SERVICE COMMUNICATOR

Subject: Q MODEL DISPENSER RETAINER CLIP

INSTALLATION INSTRUCTIONS
RETAINER CLIP Q-DISPENSER S.S. WRAP
Kit part number 76-2925-3

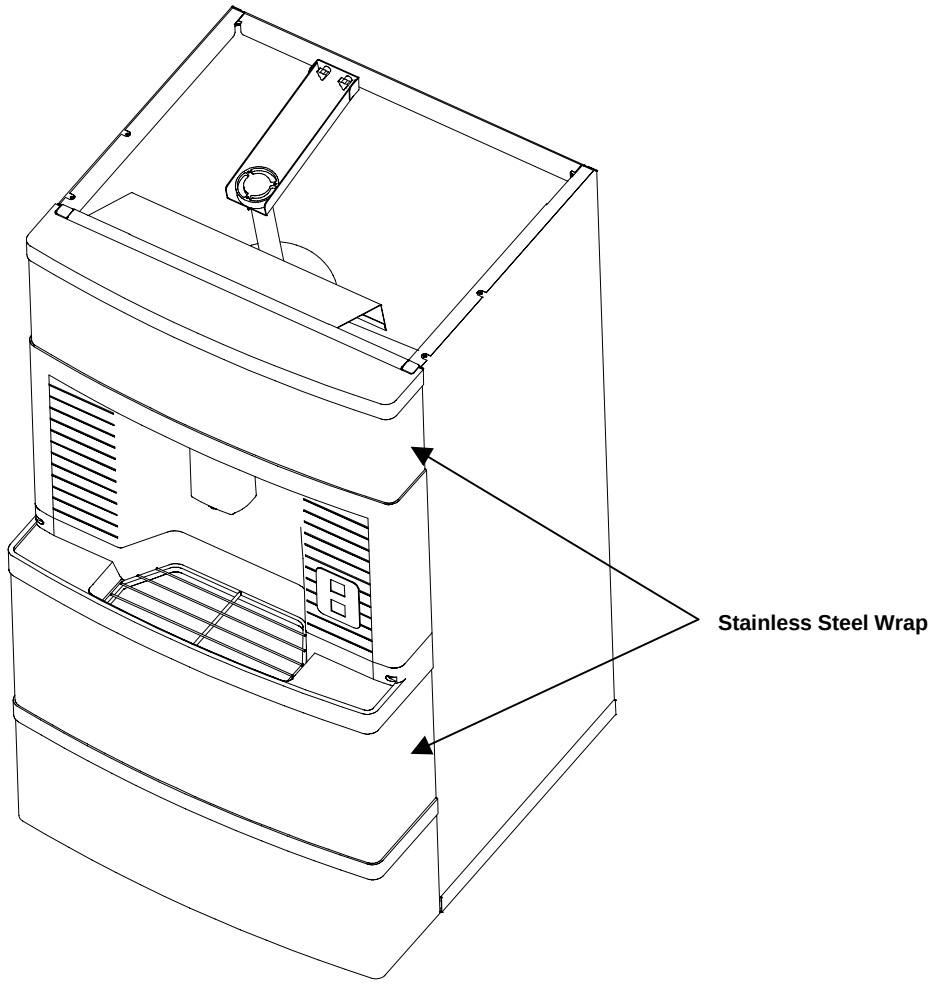
Q Model Dispensers incorporate two stainless steel wraps, which fold around the plastic edge of the front door. There have been instances of this wrap releasing from the plastic edge on some units with a serial number prior to 980700000. If this is encountered, there are stainless steel retainer clips available to secure the wrap in place.

Order part number 76-2925-3

This kit contains four stainless steel clips and mounting instructions. (A copy of the installation instructions are on the reverse side). The kit will be supplied at no charge through your local Manitowoc Distributor. Labor claims can be submitted for up to 30 minutes, through normal channels using the standard warranty labor claim form.

1. Remove the two screws that hold the front panel in place, and remove the front panel assembly.
2. Position the panel so that you are looking at the backside.
3. Cut or peel away enough of the insulation to install the retaining clip.
   NOTE: See illustrations
4. Remove the backing from the double-sided tape on the clip.
5. Position the clip 90 degrees to the back panel.
6. Roll the clip to the inside of the panel pressing firmly on the tape.
   NOTE: Be sure that the clip slides over both the stainless side panel and the plastic edge of the front panel.
7. Repeat steps 3-7 for all clips.
